AS-BUILT

VESSEL: FRV40 CLASS 63m FISHERIES RESEARCH VESSEL

TITLE: HULL STERNBODY SCANTLINGS FR. 49 – FR. 82

DWG NO. M282-110-FH04 SH 1

PLAN 14-C ⚠8 ⚠2 ⚠1

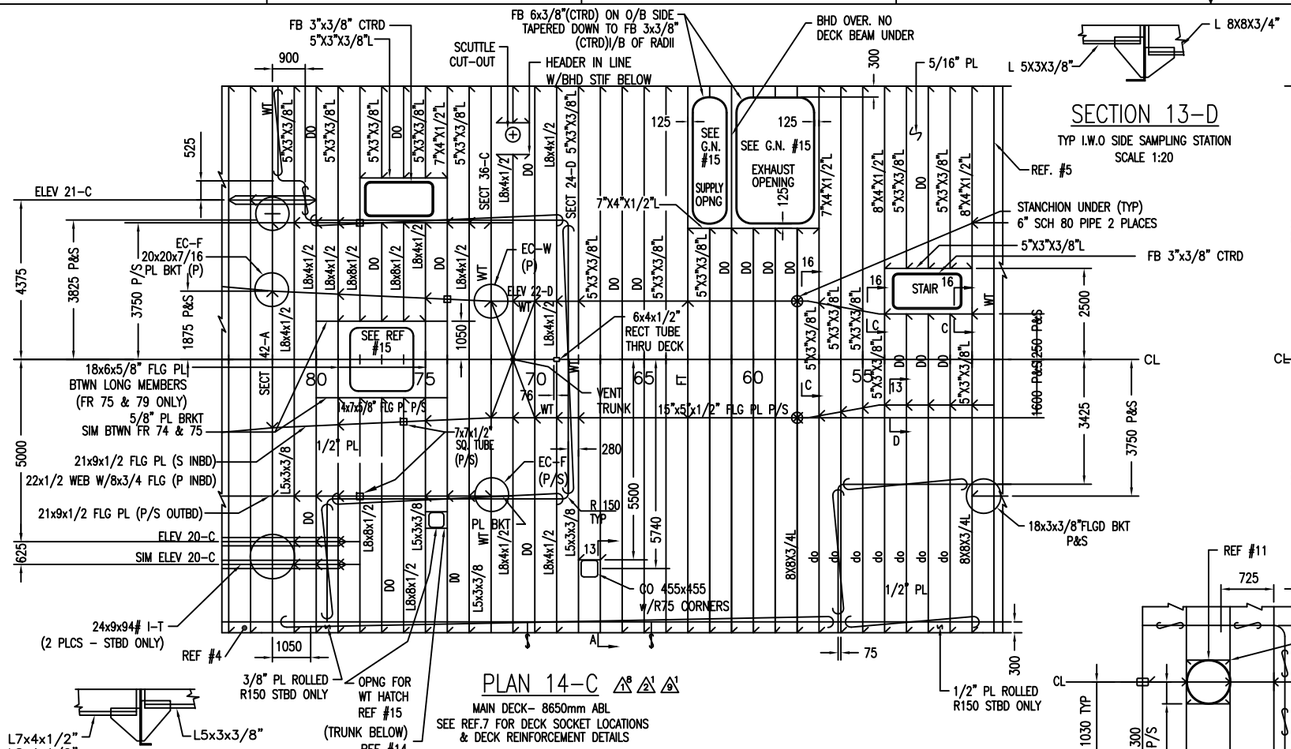
2		1. SH 2, PLAN 14-C: REVISED DIMENSIONS TO LONG'L DECK GIRDER BELOW STBD CRANE PEDESTAL FROM 5290 TO 5000 AND FROM 570 TO 625 TO SUIT RELOCATION OF STBD CRANE PEDESTAL. 2. SH 2, PLAN 10-C: RELOCATED STBD CRANE PEDESTAL FROM 5700 TO 5400 OCL AND REVISED DK STRUCTURE AS FOLLOWS; INCREASED SIZE OF 3/4" INSERT PL FROM 3400 x 2700 TO 5000 x 2700, ADDED TWO OUTBD. RADIAL GIRDERS AND REVISED DK OVERHANG STIFFENERS TO SUIT, REVISED TRSV. GIRDERS AT FRS. 78 AND 79 TO EXTEND TO OUTBOARD OVERHANG, ADDED 19 1/2 x 1/4 COAMING AT FRS 78 & 79, AND CHANGED END CONNECTION "EC-W" EXTENTS FROM FR. 69 – AFT TO FR. 69 – 77 FOR THE DK OVERHANG STIFFENERS. DELETED KNUCKLE AT FR. 81 IN WEATHER-TIGHT LONGITUDINAL BULKHEAD, 6300 OCL, FOR CRANE PEDESTAL. 3. SH 3, ELEV. 20-C: REVISED LOCATION OF LONG'L GIRDERS FROM 5290 AND 5860 TO 5000 AND 5625 OCL, RESPECTIVELY. 4. SH 3, ELEV. 23-A: REVISED BHD TO SUIT RELOCATION OF CRANE PEDESTAL WITH THE FOLLOWING CHANGES; REINSTATED PORTLIGHT AT FR. 78, RELOCATED DOOR TO FR. 80, ADDED 1/2" PLATE INSERT, RELOCATED FREEING PORT FROM FR. 78 1/2 TO FR. 76 1/2, MODIFIED BHD STIFFENERS TO SUIT RELOCATION OF CUTOUTS, ADDED L6x4x5/16 TO BHD. DELETED KNUCKLE AT FR 81. 5. SH 5, SECT. 34-A: RELOCATED STBD GIRDERS TO SUIT CRANE PEDESTAL RELOCATION. 6. SH 6, SECT. 42-A: RELOCATED STBD CRANE PEDESTAL FROM 5700 TO 5400 OCL AND SHIFTED DECK GIRDERS TO SUIT. REVISED BHD TO SUIT PEDESTAL RELOCATION WITH THE FOLLOWING CHANGES; SHORTENED HEADERS IWO BHD CUTOUT, SHORTENED BHD STIFFENERS IWO THE LONG'L DK GIRDERS. DELETED BULKHEAD STIFFENERS THAT WERE ADDED IN REV. 1. 7. SH 7, ELEV. 24-B: REVERT 5/16" PL INSERT TO 1/2" TO SUIT ORIGINAL CONFIGURATION. ITEMS 1 THRU 7 PER PROGRAM MANAGER.	8/10/04 RMW	8/11/04 RG

PLAN 10-C ⚠9,15 ⚠2 ⚠4 ⚠3,4 ⚠8

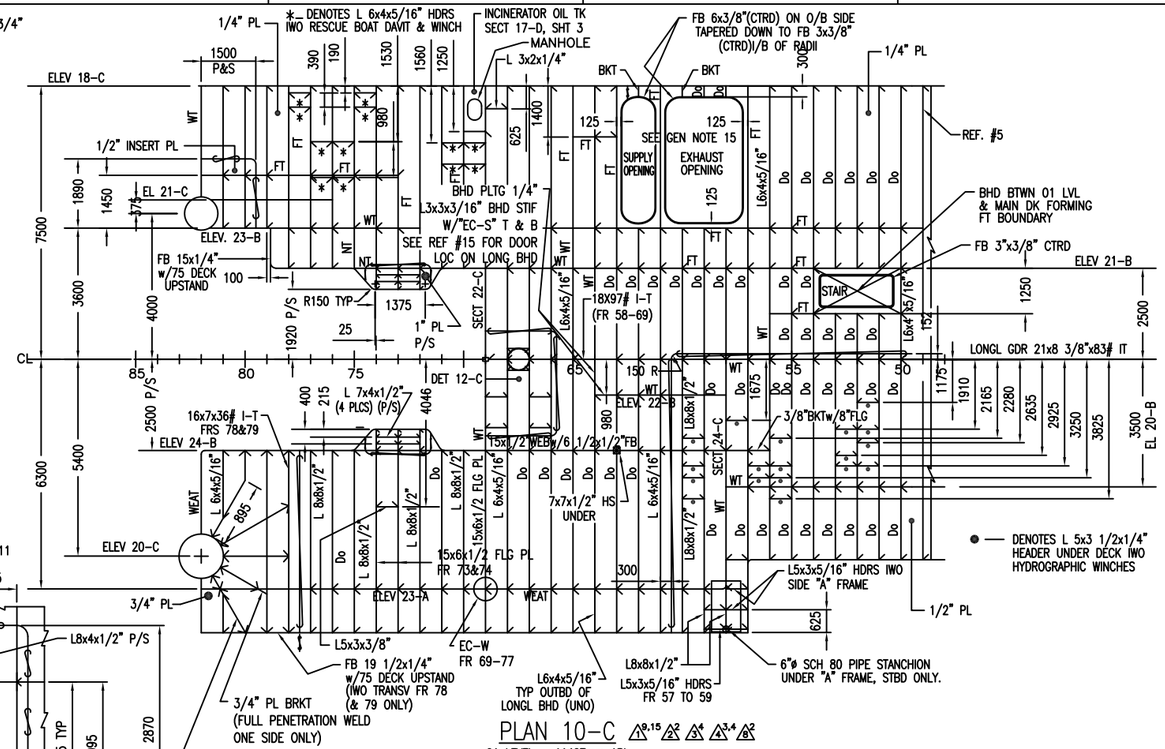
REV	ZONE	DESCRIPTION	DATE	APPROVED
3 CONT'D		4. SHT 2, PLAN 10-C: ADDED ELEV. 22-B CALL-OUT TO LONG'L BHD. 5. SHT 3, SECT. 24-C: REVISED BHD TO SUIT NEW DOOR SIZE AND LOCATION. ADDED ELEV. 22-B FOR LOG'L BHD 980 OCL (S). ITEMS 1-3 PER ENG. DEVELOPMENT. ITEMS 4 & 5 PER PRN 002 DTD. 1/31/05.		
4		1. SH 1, EXTENDED HULL APPLICABILITY TO INCLUDE HULL 1957. 2. SH 1, ADDED SH 8 TO DRAWING INDEX. 3. SH 2, ELEVATION 10-C, CHANGED PLATE THICKNESS TO 1". 4. SH 2, ELEVATION 10-C, ADDED NOTE FOR APPLICABILITY. 5. SH 3, ELEVATION 21-B, ADDED NOTE FOR APPLICABILITY. 6. SH 3, ELEVATION 22-B, ADDED NOTE FOR APPLICABILITY. 7. SH 4, SECTION 27-C, ADDED NOTE FOR APPLICABILITY. 8. SH 5, SECTION 39-A, ADDED NOTE FOR APPLICABILITY. 9. SH 7, ELEVATION 54-A, ADDED NOTE FOR APPLICABILITY. 10. SH 8, ADDED TO SHOW SCANTLINGS SPECIFIC TO HULL 1956. ITEMS 1 THRU 3 PER ENGINEERING DEVELOPMENT ITEMS 4 THRU 10 PER ECP 056B.	7/18/06 MDP	7/24/06 SM

ELEVATION 20–C ⚠1,10⚠3
LKG TO PORT
STBD SIDE CRANE PEDESTAL

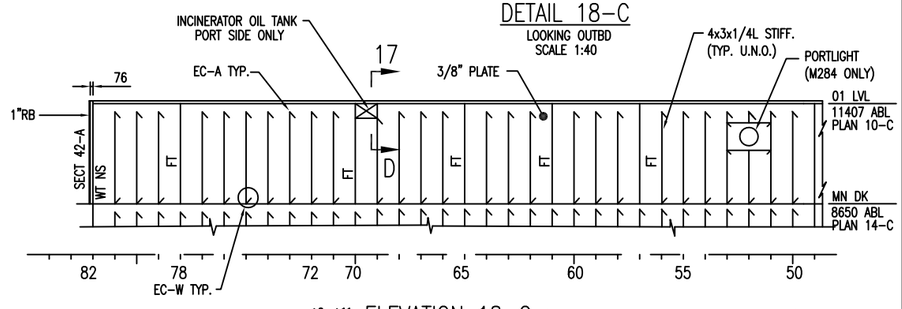
REV	ZONE	DESCRIPTION	DATE	APPROVED
1		1. SH 3, ELEV. 20-C: REVISED LONG'L GIRDER TRANSITION BKT FROM STRAIGHT TO RADIUS CUT TO CLEAR HPU MOTOR PULL SPACE. 2. SH 5, SECT. 36-4: DELETED 1/4 PL BKTS (NS) W/4x3/8 RIDER PLATES AND REINSTATED L4x3x1/4 TO SUIT REMOVAL OF BUILT-IN WINCH FOUNDATION. 3. SH 5, SECT. 36-C: DELETED 3/8 PL TAB LOCATED IWO CL ABOVE 4500 FLAT FOR BUILT-IN WINCH FDN. PLATE REMOVED TO SUIT REMOVAL OF SAID WINCH FDN. 4. SH 5, SECT. 34-B: DELETED BUILT-UP FLOOR STRUCTURAL ASSY ABOVE 4500 ABL TO SUIT REMOVAL OF BUILT-IN WINCH FDN. 5. SH 5, SECT. 34-D: DELETED 1/4 PL BKTS (NS/FS) W/4x3/8 RIDER PLATES AND REINSTATED L4x3x1/4 TO SUIT REMOVAL OF BUILT-IN WINCH FDN. 6. SH 7, ELEV. 54-A: DELETED BUILT-UP FLOOR STRUCTURAL ASSY ABOVE 4500 ABL TO SUIT REMOVAL OF BUILT-IN WINCH FDN. 7. SH 7, PLAN 55-C: DELETED RAISED PLATFORM USED AS PART OF WINCH FDN. 8. SH 2, PLAN 14-C: REVISED DIMENSIONS TO LONG'L DECK GIRDER BELOW STBD CRANE PEDESTAL FROM 5000 TO 5290 AND FROM 625 TO 570 TO SUIT RELOCATION OF STBD CRANE PEDESTAL. 9. SH 2, PLAN 10-C: RELOCATED STBD CRANE PEDESTAL FROM 5400 TO 5700 OCL AND REVISED DK STRUCTURE AS FOLLOWS; REDUCED SIZE OF 3/4" INSERT PL FROM 5000 x 2700 TO 3400 x 2700, DELETED TWO OUTBD. RADIAL GIRDERS AND REVISED DK OVERHANG STIFFENERS TO SUIT, REVISED TRSV. GIRDERS AT FRS. 78 AND 79 TO STOP AT LONG'L BHD 6300 OCL, DELETED 19 1/2 x 1/4 COAMING AT FRS 78 & 79, AND CHANGED END CONNECTION "EC-W" EXTENTS FROM FR. 69 – 77 TO FR. 69 – AFT FOR THE DK OVERHANG STIFFENERS. MODIFIED WEATHER-TIGHT BHD, 6300 OCL, WITH A KNUCKLE ADDED AT FRAME 81. 10. SH 3, ELEV. 20-C: REVISED LOCATION OF LONG'L GIRDERS FROM 5000 AND 5625 TO 5290 AND 5860 OCL, RESPECTIVELY. 11. SH 3, ELEV. 23-A: REVISED BHD TO SUIT RELOCATION OF CRANE PEDESTAL WITH THE FOLLOWING CHANGES; DELETED PORTLIGHT AT FR. 78, RELOCATED DOOR TO FR. 77, DELETED 1/2" PLATE INSERT, RELOCATED FREEING PORT FROM FR. 76 1/2 TO FR. 78 1/2, MODIFIED BHD STIFFENERS TO SUIT RELOCATION OF CUTOUTS, DELETED L8x4x5/16 FROM BHD, ADDED A KNUCKLE AT FR. 81 TO ALLOW THE BHD TO PERPENDICULARLY INTERSECT THE CRANE PEDESTAL. 12. SH 5, SECT. 34-A: RELOCATED STBD GIRDERS TO SUIT CRANE PEDESTAL RELOCATION. 13. SH 6, SECT. 42-A: RELOCATED STBD CRANE PEDESTAL FROM 5400 TO 5700 OCL AND SHIFTED DECK GIRDERS TO SUIT. REVISED BHD TO SUIT PEDESTAL RELOCATION WITH THE FOLLOWING CHANGES; EXTENDED HEADERS IWO BHD CUTOUT, EXTENDED BHD STIFFENERS TO MN DK THAT WERE IN LINE OF THE LONG'L DK GIRDERS, ADDED TWO NEW BHD STIFFENERS TO SUIT RELOCATED DECK GIRDERS. 14. SH 3, ELEV. 24-B: CHANGED 1/2" INSERT PL TO 5/16" THK. 15. SH 2, PLAN 10-C: ADDED 5/16" INSERT PL IWO NET REEL FOUNDATION, P/S. ITEM 1 PER PRN #001, DTD 1/28/04. ITEMS 2 THRU 7 PER REWORK #741-0004 ITEMS 8 THRU 15 PER ENGINEERING DEVELOPMENT	1/28/04 AGE 2/26/04 AGE 3/22/04 AGE 3/30/04 AGE	4/5/04 RG

ELEVATION 21–B ⚠5⚠2⚠3
NT/WT LONG'L BHD 2500 OCL PORT
LKG OUTBD
M282 ONLY
FOR M283 & M284 SEE ELEV 62–D

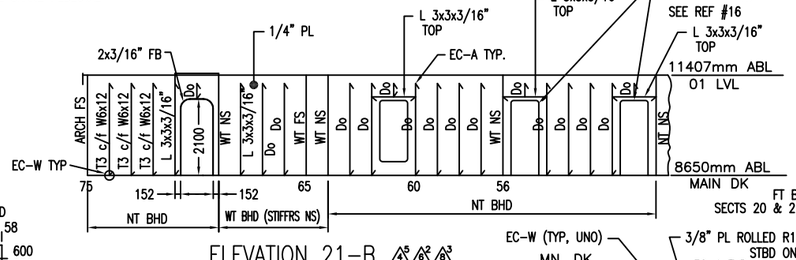
REV	ZONE	DESCRIPTION	DATE	APPROVED
6		1. SH 1, REFERENCES: ADDED REF #16, FH26 JOINER DOOR SCHEDULE, TO REFERENCES. 2. SH 3, ELEVATION 21-B: EXTENDED BHD TO FR 49 AND DETAILED CLEAR OPENINGS FOR STAIRWELL JOINER DOORS. 3. SH 8, ELEVATION 62-D: EXTENDED BHD TO FR 49 AND DETAILED CLEAR OPENINGS FOR STAIRWELL JOINER DOORS. 4. SH 1, ADDED SH 1A TO DRAWING INDEX AND REVISION STATUS. ITEM 1 THRU 3 PER ENGINEERING DEVELOPMENT	11/07/06 MDP	11/13/06 SM
7		1. SH 1, DRAWING INDEX & REVISION STATUS; ADDED SHT 10. PROPULSION XFMR MOVED AFT TO MAKE ADEQUATE SPACE BETWEEN XFMR AND GENERATOR FOR PASSAGE. SHT 10 DETAILS ADDITIONAL UNDERDECK STRUCTURE FOR XFMR RELOCATION. 2. SH 2, PLAN 14-A; ADDED NOTE REGARDING APPLICABILITY. CHANGED SCANTLING TWO 24"X24" EOS HATCH FOR M283/M284. 3. SH 7, ELEVATION 54-D, PLAN 54-C, ELEVATION 52-D & ELEVATION 51-D; ADDED NOTE REGARDING APPLICABILITY. ITEM 1 & 3 PER VENDOR CHANGE ITEM 2 PER ENGINEERING CHANGE THIS REVISION APPLICABLE TO M283/M284 ONLY	4/10/07 MDP	4/17/07 SM

8		1. SH 1, DRAWING INDEX; REVISED APPLICABILITY NOTE. 2. SH 2, ELEVATION 10-C; REVISED APPLICABILITY NOTE. 3. SH 3, ELEVATION 21-B; REVISED APPLICABILITY NOTE. 4. SH 3, ELEVATION 22-B; REVISED APPLICABILITY NOTE. 5. SH 4, SECTION 27-C; REVISED APPLICABILITY NOTE. 6. SH 5, SECTION 39-A; REVISED APPLICABILITY NOTE. 7. SH 7, ELEVATION 54-A; REVISED APPLICABILITY NOTE. 8. SH 8, ALL; REVISED APPLICABILITY NOTE. 9. SH 8, ELEVATION 62-D; REVISED DOOR LOCATION. 10. SH 3, ELEVATION 20-B; ADDED APPLICABILITY NOTE. 11. SH 3, ELEVATION 18-C; ADDED WINDOW @ FR 52, PORT SIDE ONLY. 12. SH 10, ELEVATION 74-C & ELEVATION 74-D; ADDED ELEVATIONS SHOWING BHD 3500 OCL FOR M283 & M284. 13. SH 8, PLAN 59-B; ADDED 6"x4"X5/16" L AT 7146mm OCL BTW FR 80 & FR 82. ITEMS 1 THRU 12 PER PER ECP 056C. ITEM 13 PER ECP 095. THIS REVISION APPLICABLE TO M283/M284 ONLY.	10/9/08 MDP	11/10/08 DH
9		1. SH 2, PLAN 14-C; CHANGED BRACKET AT 1875 OCL PORT TO 20"x20". 2. SH 3, ELEVATION 18-C; CHANGED FROM WINDOW TO PORTLIGHT. 3. SH 6, SECTION 42-A; ADDED DETAILS OF OUTRIGGER CONNECTION SUPPORT STRUCTURE. 4. SH 8, PLAN 59-B; REMOVED 6x4x5/16" L PORT SIDE BETWEEN FRAMES 80 AND 82. ITEM 1 PER OWNER REQUEST. ITEM 2 PER USCG REQUIREMENT. ITEM 3 & 4 PER YARD REQUEST. THIS REVISION APPLICABLE TO M283/M284 ONLY.	6/10/09 MDP

SECTION 34-B ⚠4 ⚠3

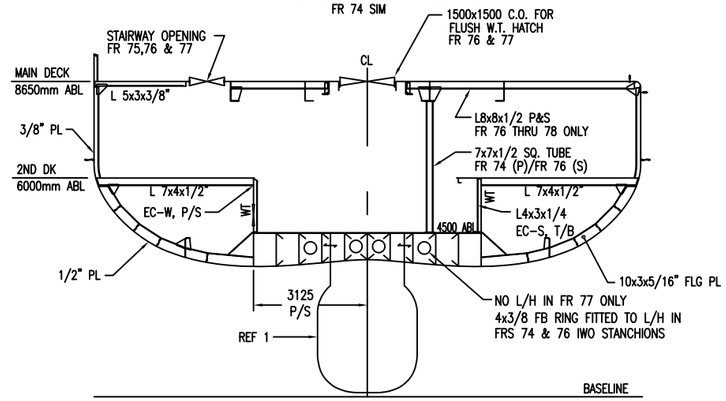
3		1. EXTENDED HULL APPLICABILITY TO INCLUDE HULL 1956. 2. SHT 3, ELEV. 23-B & 21-C: SPECIFIED PIPE STUB TO BE SHIPYARD SUPPLIED. 3. SHT 5, SECT. 34-B REVISED CALLOUT TO INCLUDE FR 74 TO BE FITTED W/ FB IWO LH. (CONT'D ZONE 4-D)	3/21/05 RMW	3/30/05 RG

PLAN 51-C [3,4,5]

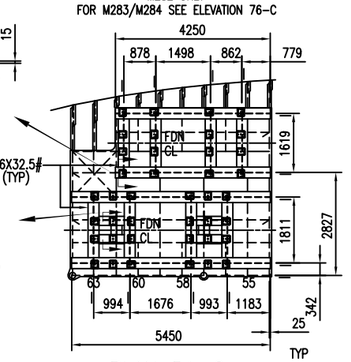
5		1. SH 1, THIS REVISION REFLECTS AS-BUILT CONDITIONS FOR HULL 1953. 2. SH 1, ADDED SH 9 TO DRAWING INDEX AND REVISION STATUS. 3. SH 1, ADDED GENERAL NOTE #17 SPECIFYING SURFACE TOLERANCES FOR GENERATOR FOUNDATION. 4. SH 7, PLAN 51-C, ADDED NOTE REGARDING APPLICABILITY. 5. SH 7, PLAN 51-C, ADDED STRUCTURE TO M282 GENERATOR FDN TO MATCH AS-BUILT CONDITION. ITEMS 1 THRU 5 PER ENGINEERING DEVELOPMENT	8/22/06 MDP	9/6/06 MDP
